Addendum #1

Bid Opportunity: RFT-2025-166 - Operations Centre Garage Expansion

ORANGEVILLE OPERATION CENTRE

PROJECT NO.: B22-367.32

Sheet Title
HVAC PLAN

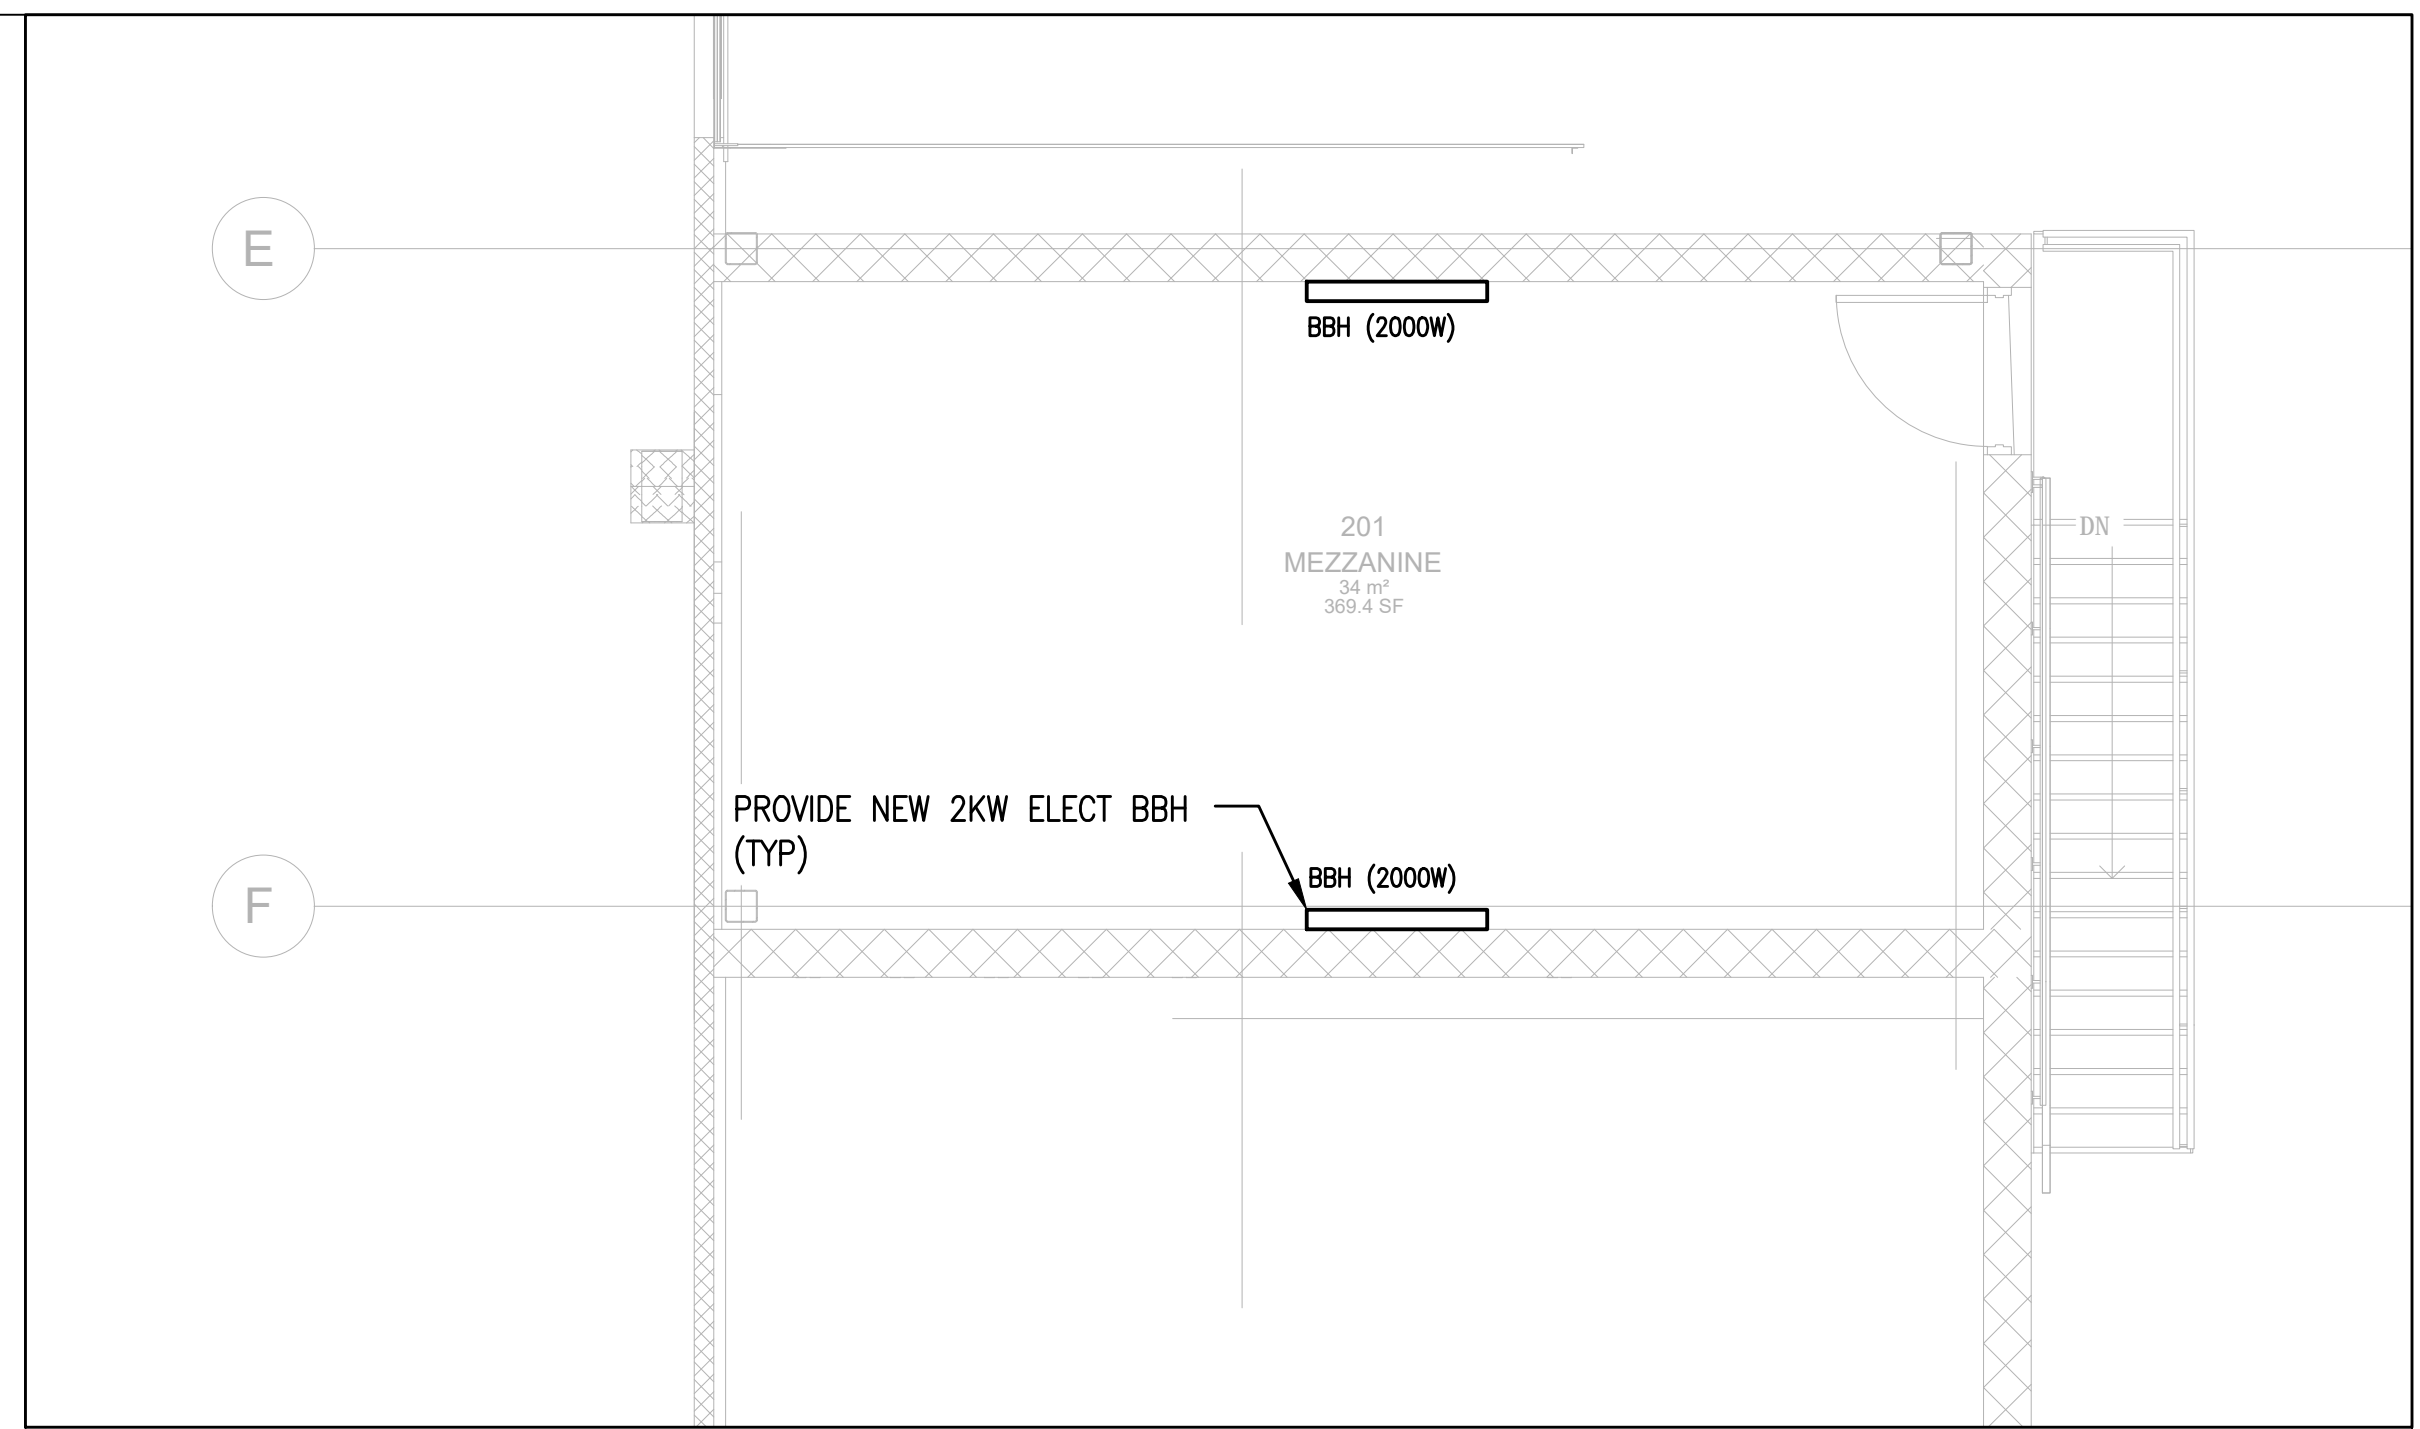
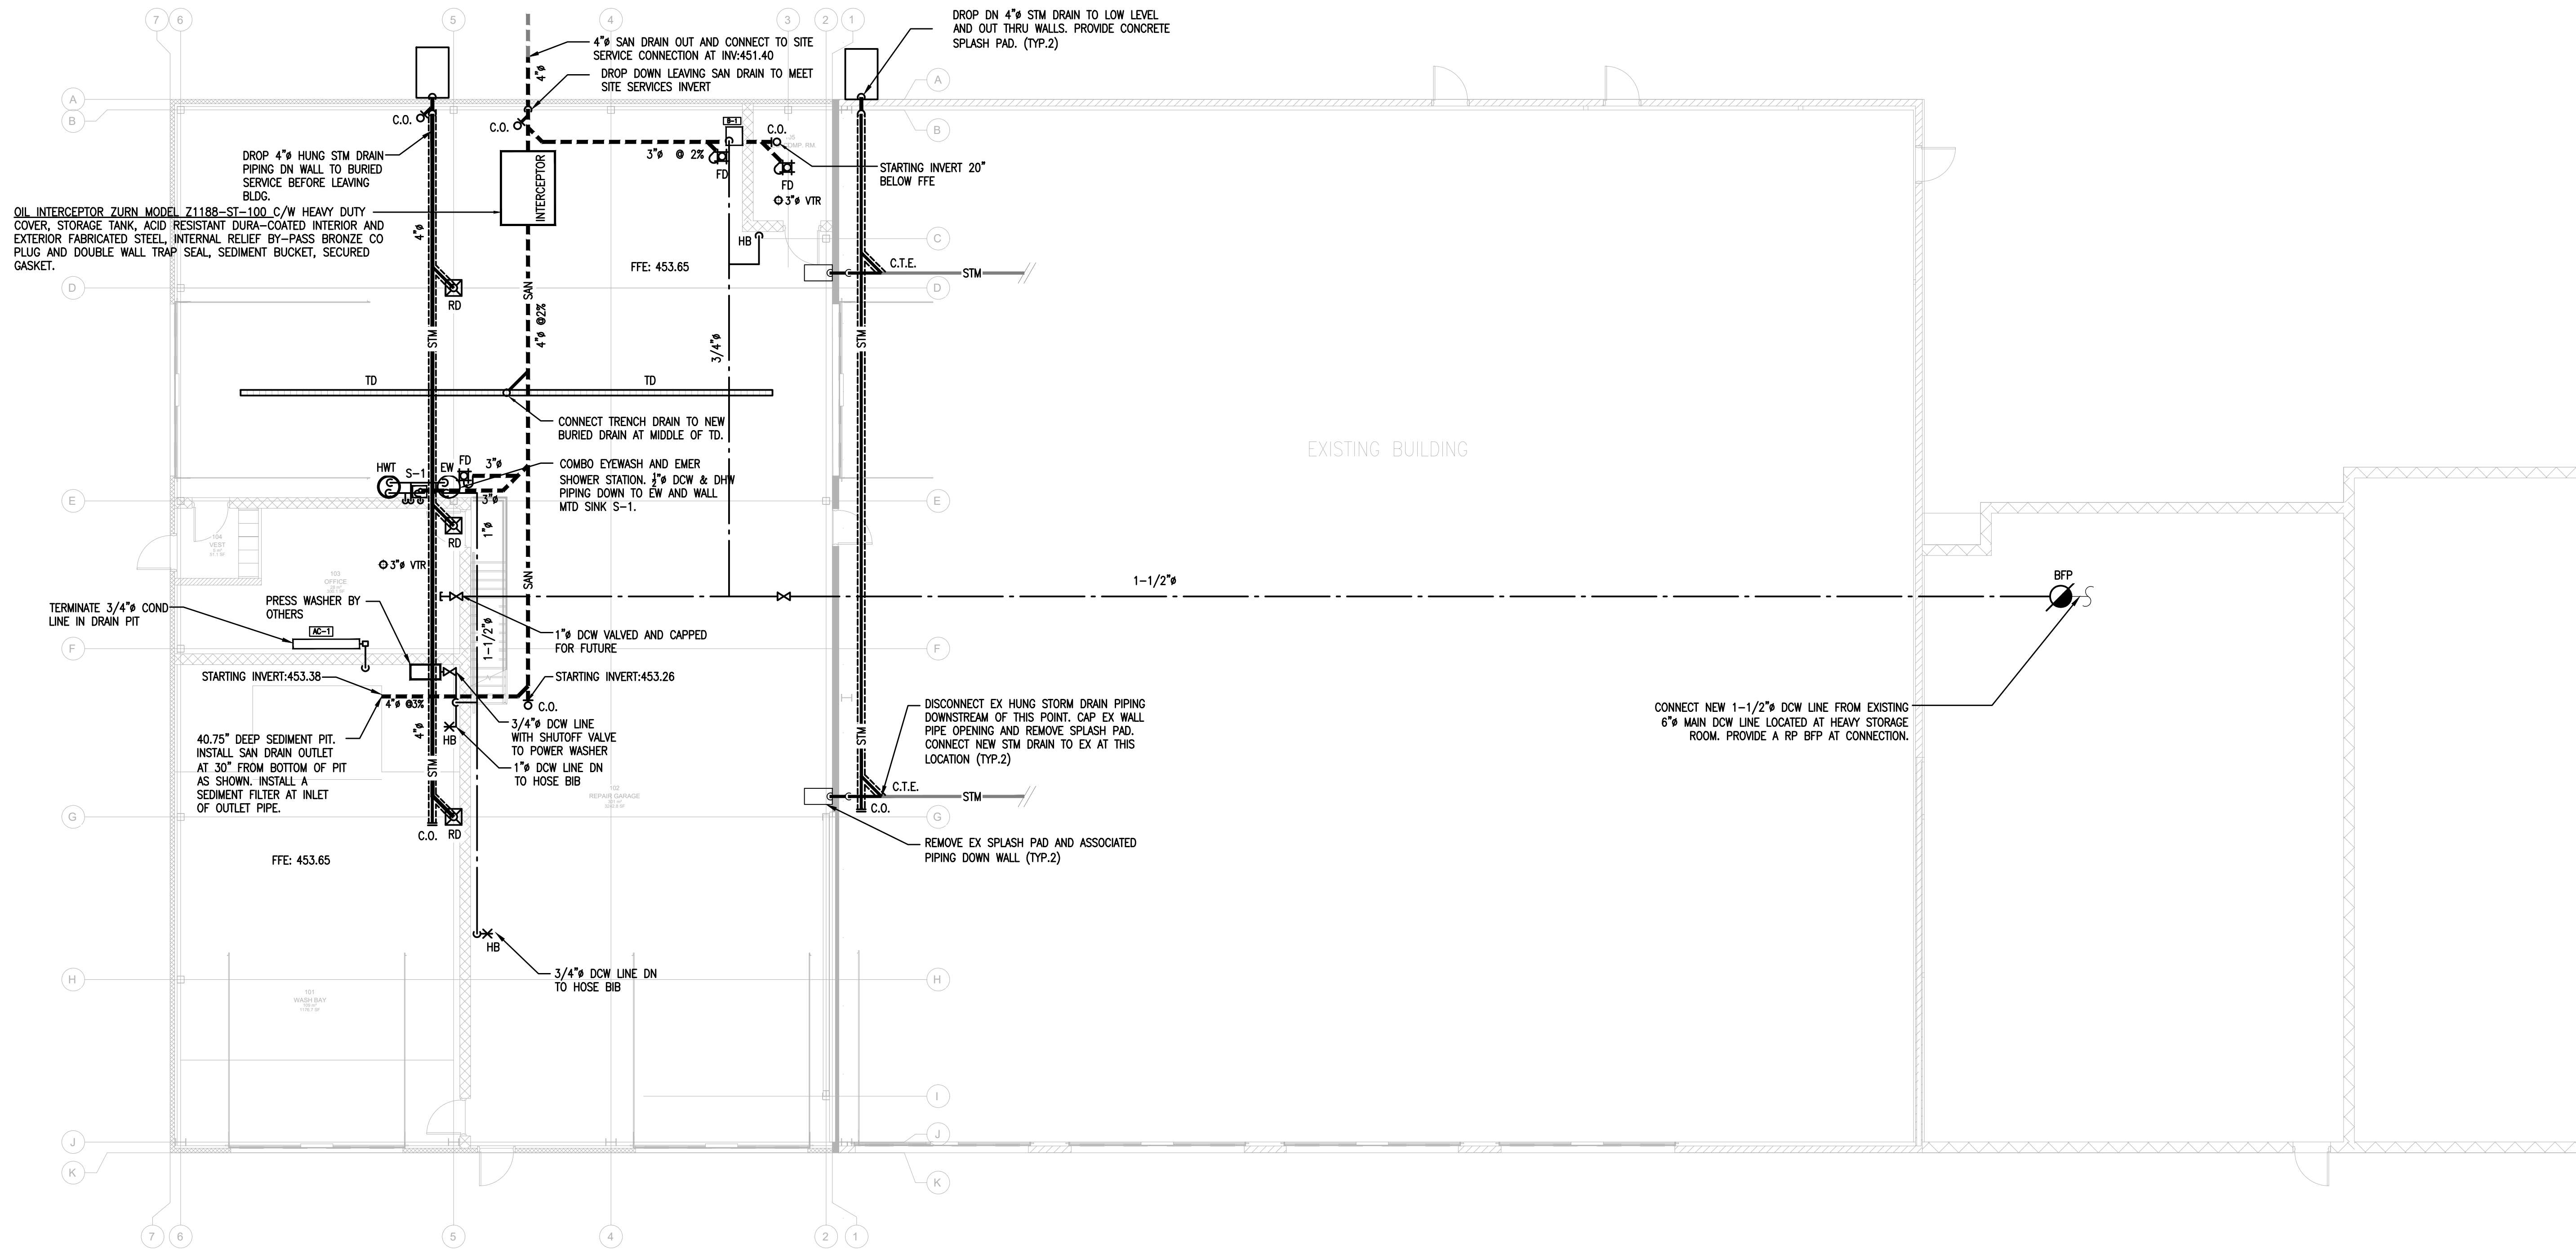
Mechanical drawings include corrupted characters. Please advise.
(you can see this on plan number for instance)

Answer 3: The corrupted characters on the mechanical drawings have been corrected and the drawings included with this addendum.
